MIL-PRF-83536/4
AMENDMENT 2
10 July 1999
SUPERSEDING
AMENDMENT 1
15 December 1995

PERFORMANCE SPECIFICATION SHEET

RELAYS, ELECTROMAGNETIC, ESTABLISHED RELIABILITY, DPDT,
LOW LEVEL TO 5 AMPERES, PERMANENT MAGNET DRIVE, MAGNETIC LATCH,
HERMETICALLY SEALED, ALL WELDED, TRANSIENT SUPPRESSED DC COILS

CIRCUIT DIAGRAM
(OPTIONAL INTERNAL
DIODE CONFIGURATION)

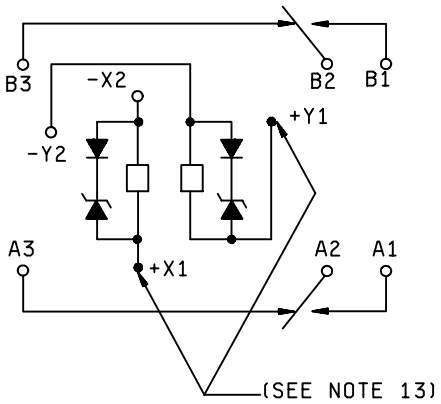
FIGURE 1, add the following circuit diagram:

TO CLOSE A1 AND B1 CONTACTS (OPERATE)
ENERGIZE X1 AND X2
TO CLOSE A3 AND B3 CONTACT (RESET)
ENERGIZE Y1 AND Y2
